CERTIFICATE OF APPROPRIATENESS

Issued by the Houston Archaeological and Historical Commission

ITEM A5
HPO File #: HP2026_0248

1505 Tulane Street
Houston Heights West

Side Setbacks (Addition and New Construction)

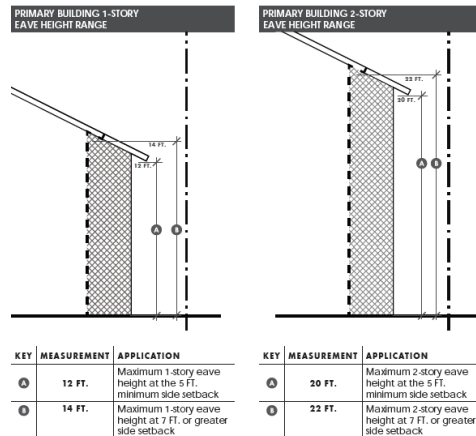
Proposed South side setback (1): 20'9", Proposed North side setback (2): 7'

Cumulative side setback: 27'9"

3D VIEWS

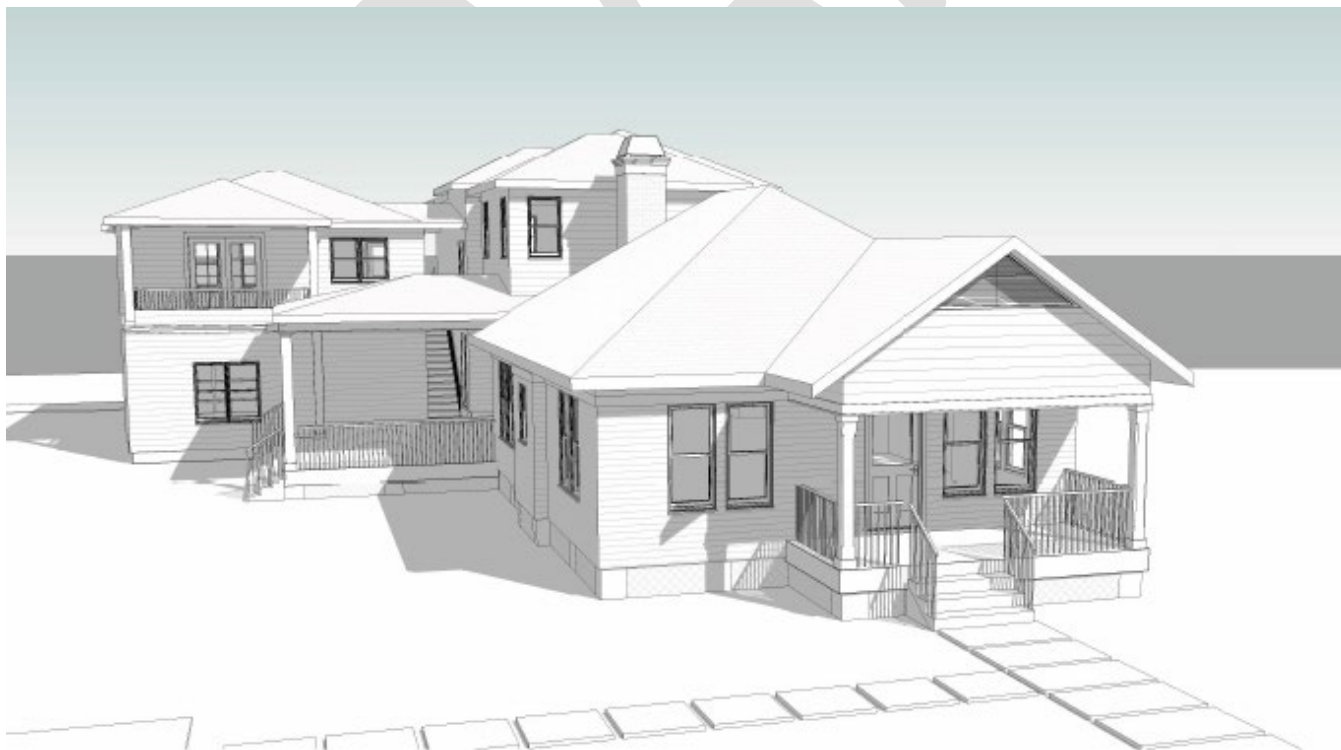
- The applicant has changed the roof on the first-floor porch and has lowered the ridge height of the roof connecting the addition of the main house to the detached garage.
